Summary of Objections for Wood Lodge Solar Farm Planning Application NE/23/00858/FUL:

This application has been poorly executed with many incorrect facts, has ignored Planning Regulations and omits many legally required surveys and should be refused.

Habitats Regulation Assessment

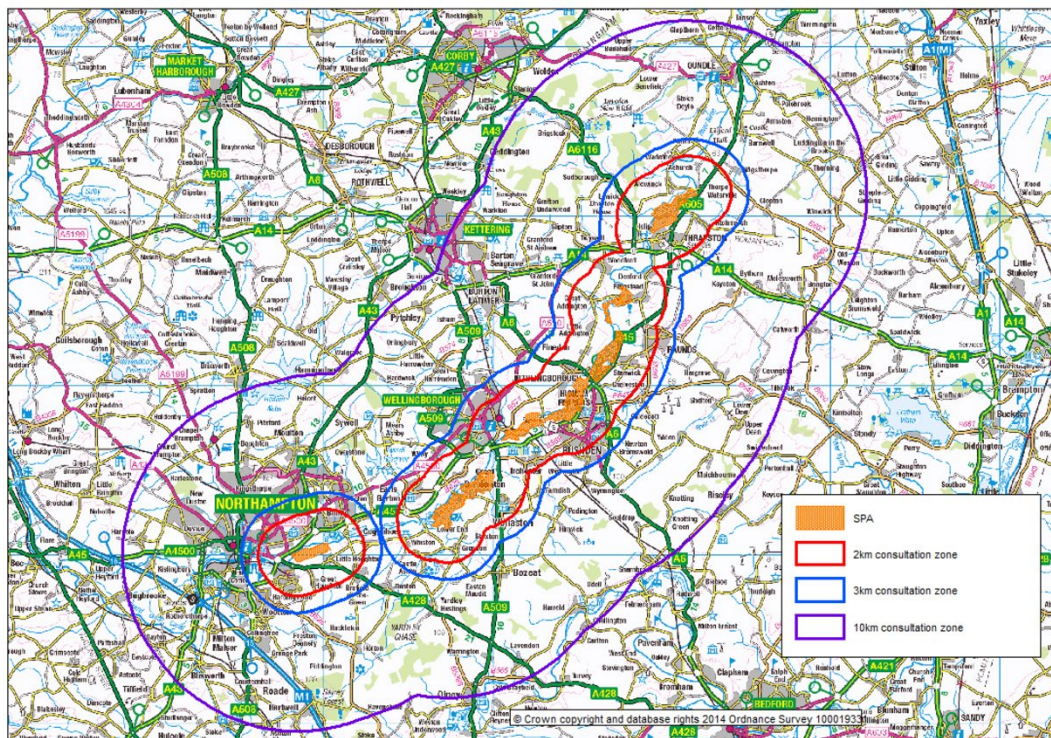
- **Legally required Shadow Habitats Regulations Assessment protecting nearby RAMSAR site and its Functionally Linked Land not submitted**

Natural England's Sebastian Shepherd has stated that this development would meet the requirements for Winter Bird Surveys etc as it is within both 10km and 3km of the SPA and is known to be within 800m of the Golden Plover seen on the Castle Manor Site and numerous other Golden Plover and Lapwing sightings.

The developers themselves say they will undertake the required HRA when requested. As it is within the FLL and 3km of SPA this is actually a requirement.

Soil Surveys and BMVL

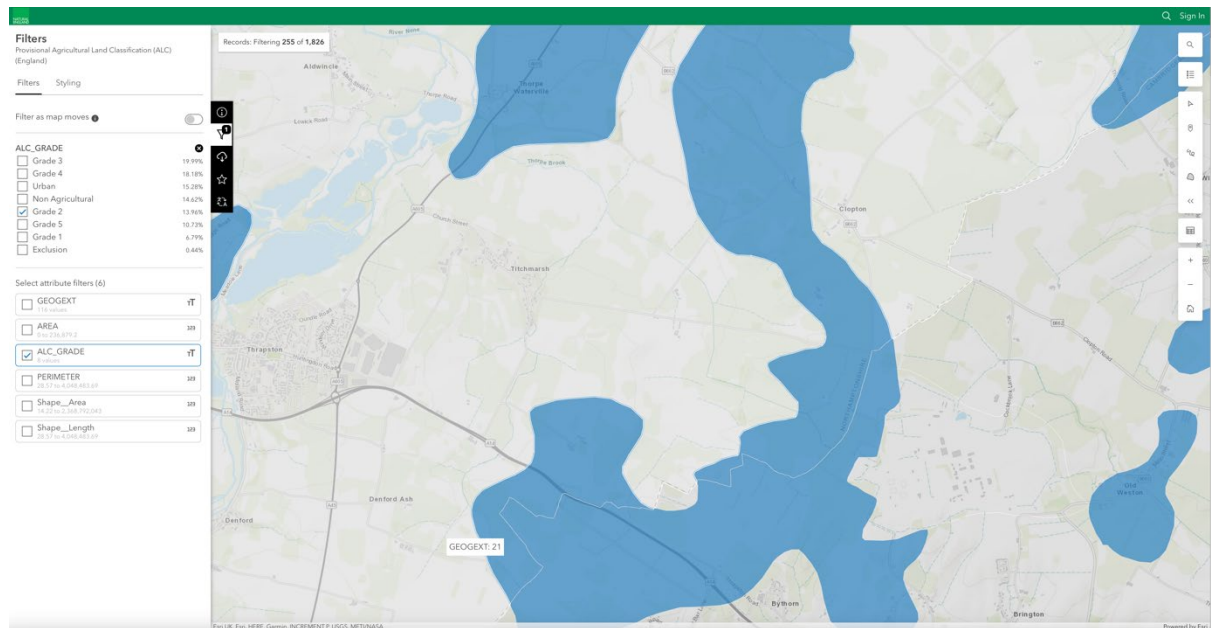
- **28ha of BMVL lost forever and even more from adjacent proposed solar farm planning applications**

The Soil Survey doesn't provide enough detail as to how they decided that the Wetness Level is III.

The data tables don't show the depth of gleying.

The developers haven't shown the 1988 ALC Map of the area but have chosen numerous other maps instead.

Is this because the ALC Map shows the entire area should be Grade 2?

The new DEFRA Provisional ALC Map (England) highlighting Grade 2 Soil areas.
